# JVR Energy Park

## Preliminary Assessment of Installed Capacity as proposed by developer

Date: 8/12/2021

The following layout shows the 90 MWac project (source: Chapter 4 Project Alternative)

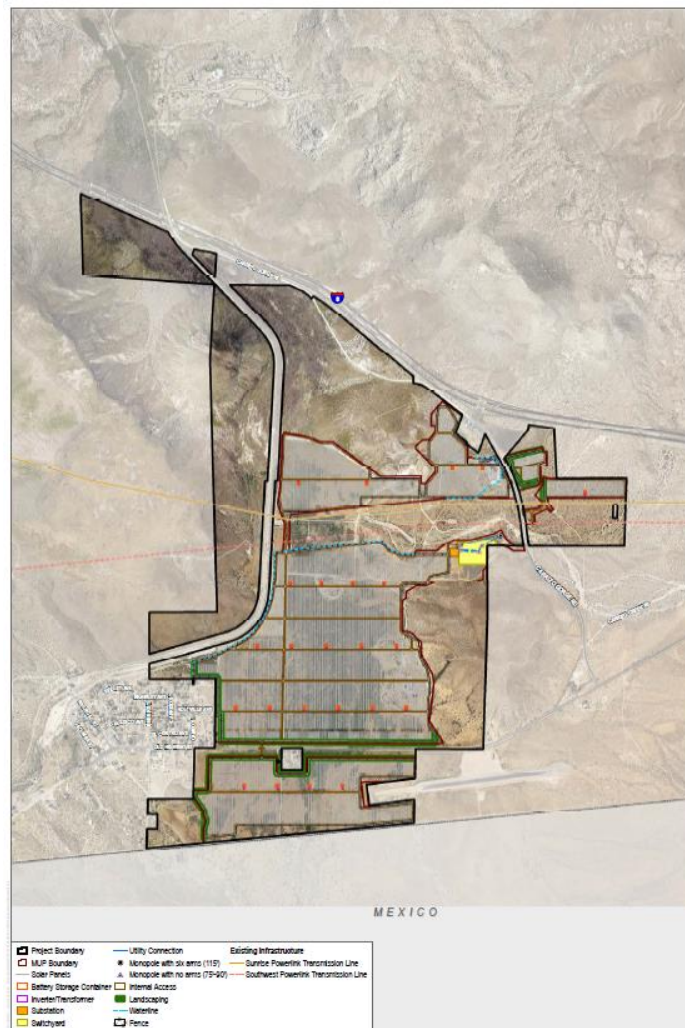
To put this into perspective, by eliminating 148 acres of panels and inverters, the entire section of the project south of Old Hwy 80 and north of the Mexico border can be eliminated. Additionally, the sections of the project along Laguna St can be pushed east by nearly 700 feet and the small section proposed behind the homes on Seeley Ave can be eliminated. The figure below shows the roughly 148 acres s of the project that could be eliminated while still meeting the fundamental project objectives of delivering 90 MW AC to the grid.

The JVR Project is a 90 MWac located at Jacumba Hot Spring, CA. the proposed project area will use 604 acres from the 24 parcels listed in the EIR.
